Groundwater Application Review Summary Form

Application # G- 18615

TO: Water Rights Section Date 4/5/2018
 FROM: Groundwater Section Aurora C Bouchier
 Reviewer's Name
 SUBJECT: Application G- 185615 Supersedes review of na
 Date of Review(s)

A. GENERAL INFORMATION: Applicant's Name: Waibel Properties, LLC County: Crook

Water-Level Trends in Nearby Wells

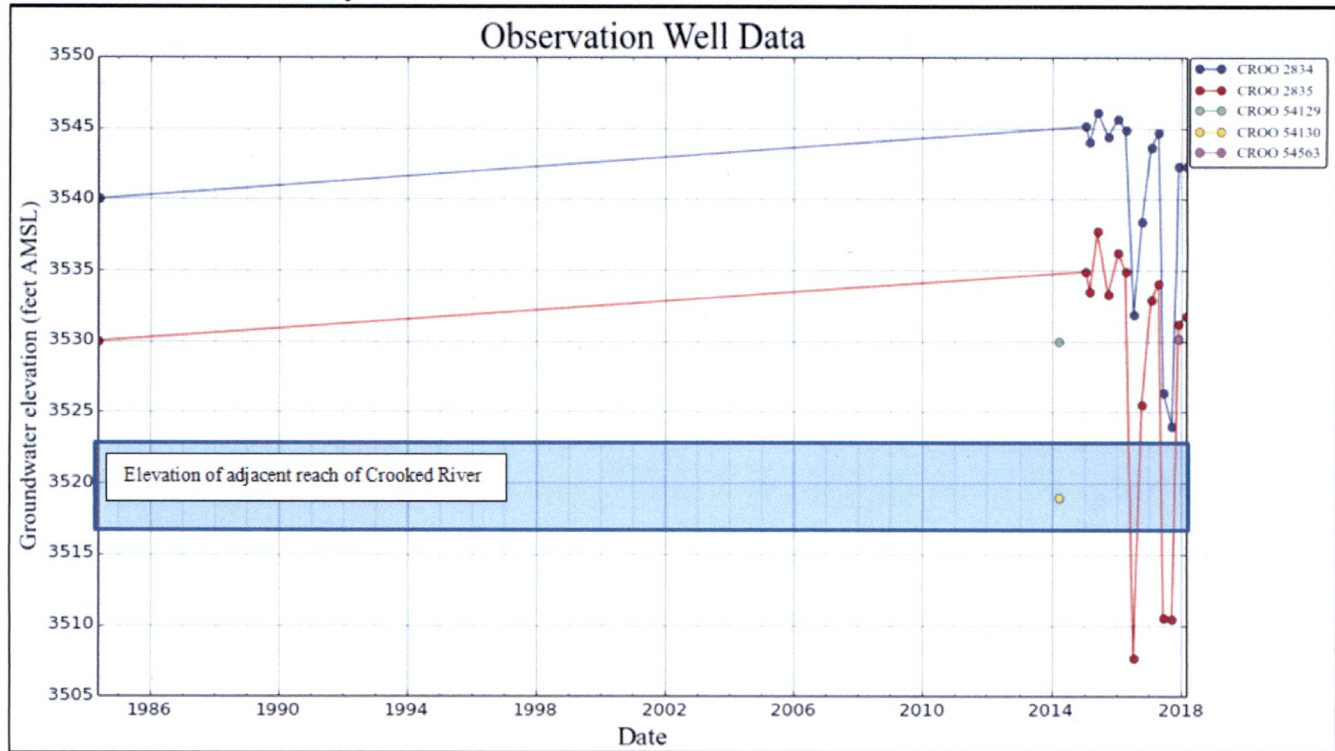
A large amount of groundwater has been, and is being, permitted in the region. In 2015 OWRD began collecting quarterly water level measurements at nearby wells CROO 2834 and CROO 2835 (see hydrograph below). The period of record for these two wells is insufficient to assess the sustainability of the resource given the recent groundwater development.

Condition with 7N and 7J. _____

Well Lithology

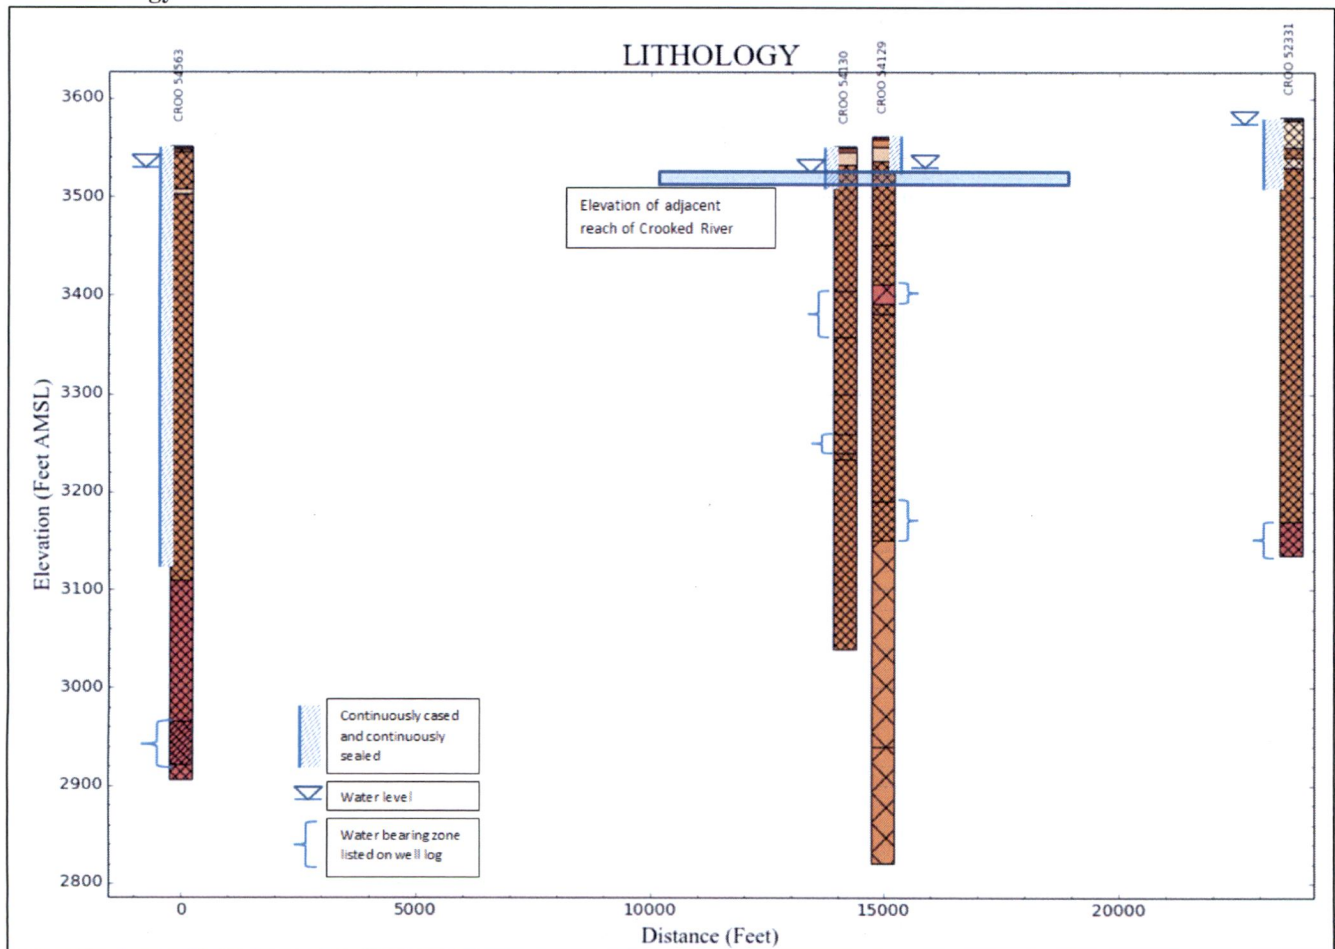
Comments: The wells are likely in hydraulic connected with the Crooked River. Interference with the river was not calculated since an appropriate model is not available for this analysis. The water bearing zones identified on the well logs for this application are at 146 and 150 feet below land surface. The overlying units consist of relatively fine-grained (low permeability) material which likely results in an inefficient hydraulic connection.

Groundwater/surface water interaction with the nearest reach of the Crooked River is unknown. Wells on nearby applications (CROO 54563 and CROO 52331 on G-18605 and G-16212 respectively) have water-bearing zones which are separated from the surface water sources by more than 400 feet of fine-grained, low permeability material. Despite the close proximity of CROO 52331 and CROO 54563 to surface water sources (1500-1600 feet), and the static water levels in the wells being at an elevation coincident with or above the adjacent reach of the surface water sources, the thick sequence of low permeability material resulted in a determination of no hydraulic connection with the surface water sources. The wells on this application (CROO 54130 and CROO 54129) have less than 150 feet of fine-grained, low permeability material above the water-bearing zones.

If a permit is issued, condition with 7N and 7J.
